APPENDIX C.2

Geotechnical Inspection Reports

RE: Submission of 2019 Geotechnical Inspection Report No. 1 (July 2020)

Annual Geotechnical Inspections – 2020 Report 1. Mary River Iron Mine Complex – Nunavut

Figure 7: Aerial view of the three PWS ponds (this photo was taken in 2019)

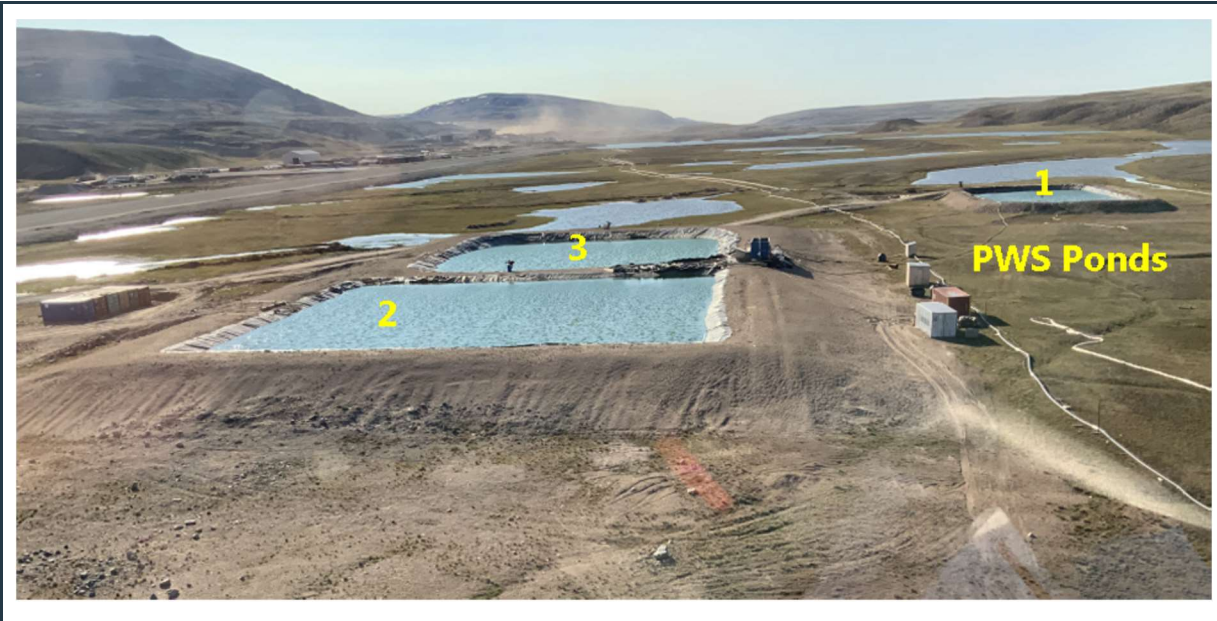
Some minor damage (i.e. "sinkhole") was visible on the crest of Pond #3, shown in Figure 10. It appears that the finer sand particles migrated down into the larger voids within the rock fill. Furthermore, large timbers and miscellaneous other elements (e.g., used tires etc.) are utilized as weight to secure the liner in-place at the berm's crest.

Baffinland Action: Baffinland commits to having the minor damage to the liner repaired as part of the regular maintenance program. Baffinland will continue to monitor the PWSPs and initiate cleanup of this area to remove excess materials.

Figure 46: Potential hazards at one of the highwalls (weak dike, loose boulders and sliding wedge).

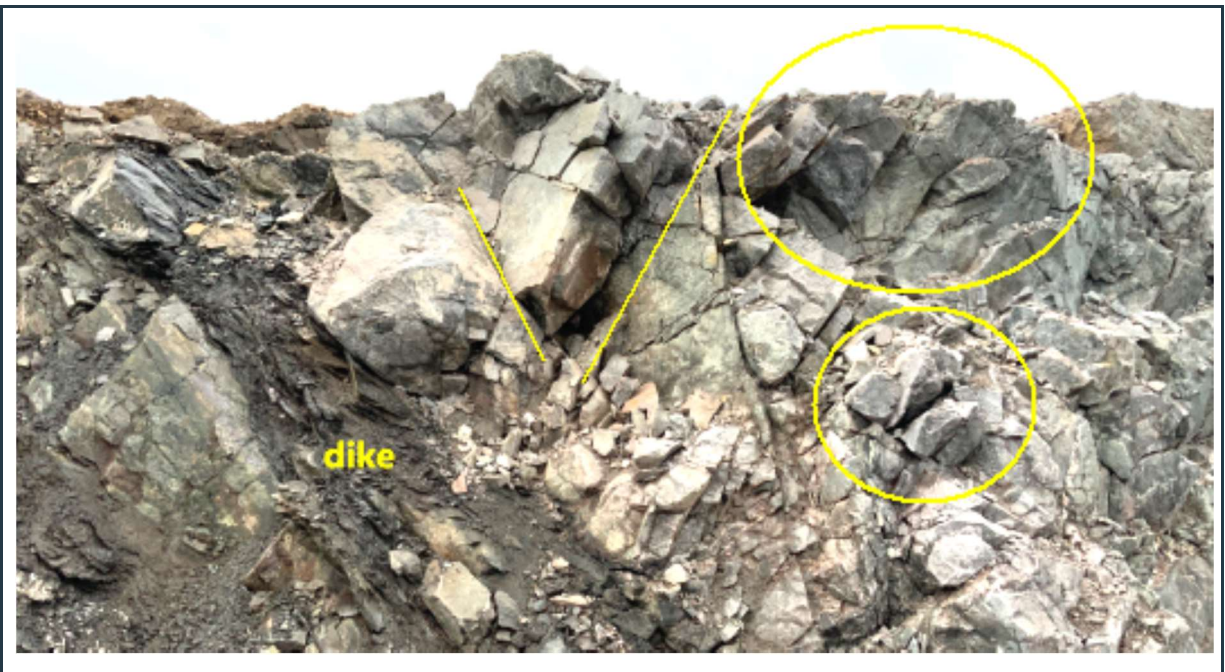
No activity was noted in the QMR2 quarry (Figure 45) at the time of the inspection. The rock slopes in the quarry generally appeared to be in stable conditions, although potential fall hazards were noted in a few areas. Such hazards, represented by the presence of weak veins within the pit walls, loose boulders, and rock wedges prone to skidding are shown in Figure 46. It is recommended that such hazards (noted at approximately 2% to 3% of the pit walls) should be eliminated by rock scaling, prior to restarting the quarry's operation.

Figure 64: Stable berm at the MP-04 landfarm with exposed liner on the downstream face of the berm.

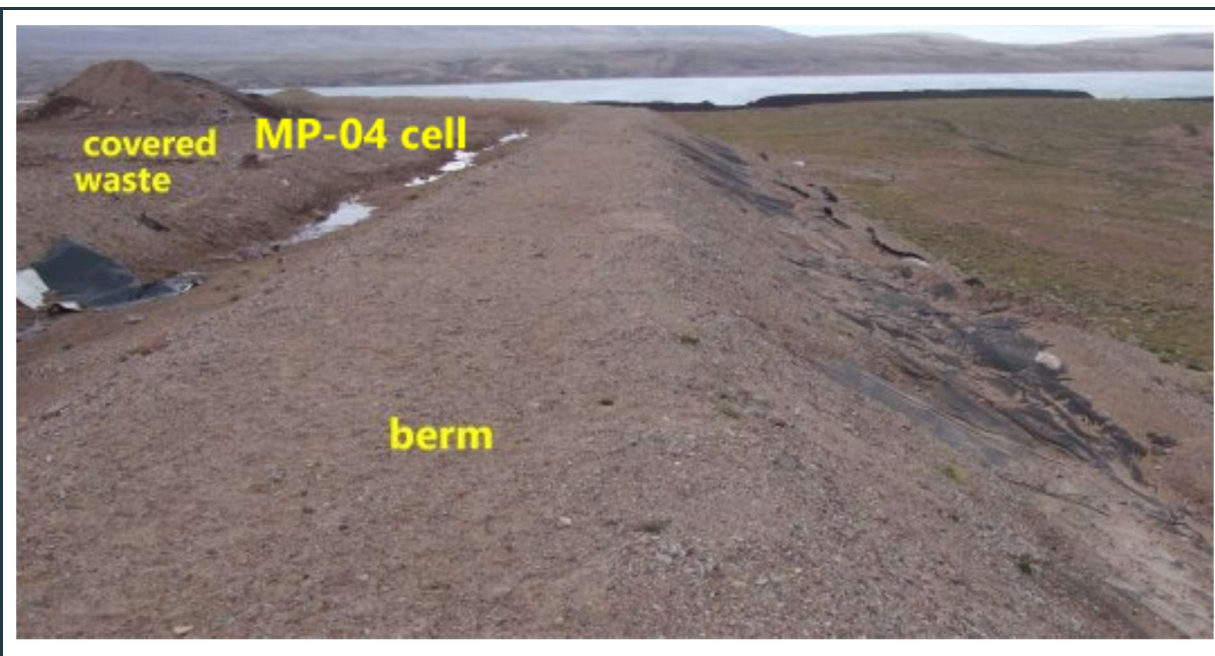
The MP-04 cell is located south of the port complex at higher elevation, adjacent to the rock quarry and it is almost full of waste materials. It is a large landfarm cell that generally stores contaminated soils and some solid waste, as shown in Figures 63 and 64. The berm structure around the cell appears to be in stable condition. The ponding water in one corner of the cell indicates proper liner functionality and no wet downstream slopes and toe seepage were noted (see Figure 63). Exposed liner was visible on the downstream slope of sections of the berm, particularly along the north berm. It is recommended that the exposed liner be covered (weighed down by a gravel layer) along the toe of the slope to prevent wind uplift related impacts.

Figure 51: View of the MP-04A contaminated snow dump cell with stable berms and ponding water.

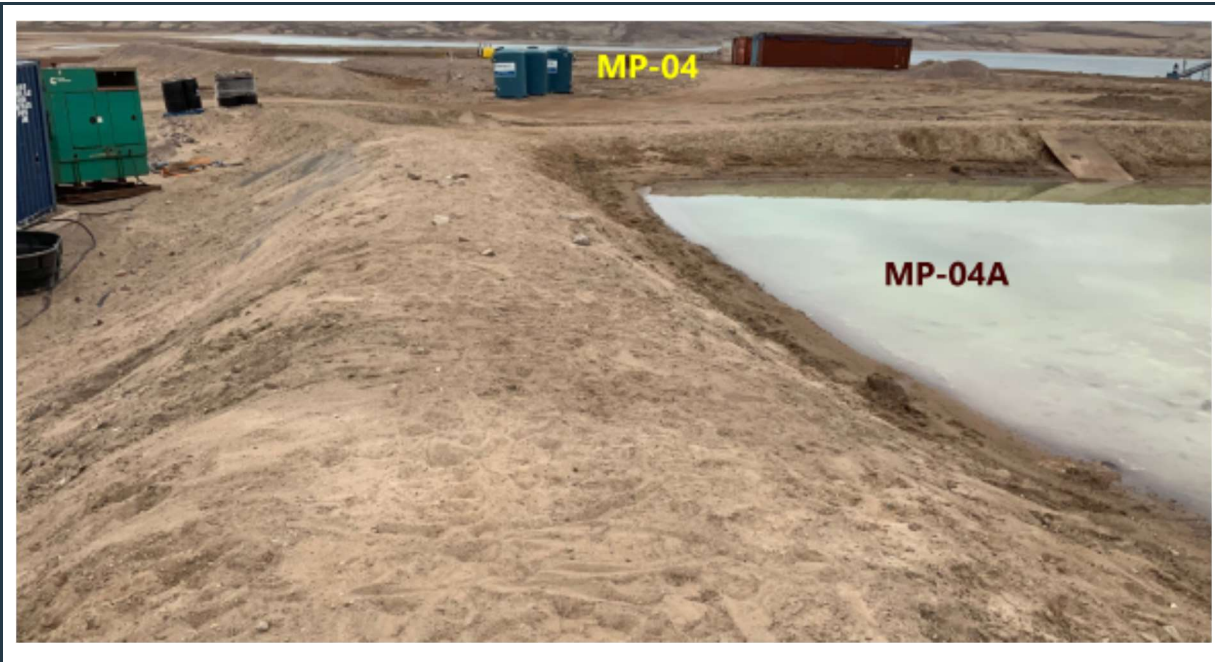
Figure 52: Condition of the ramp to the MP-04A snow dump, with exposed liner (yellow circle).
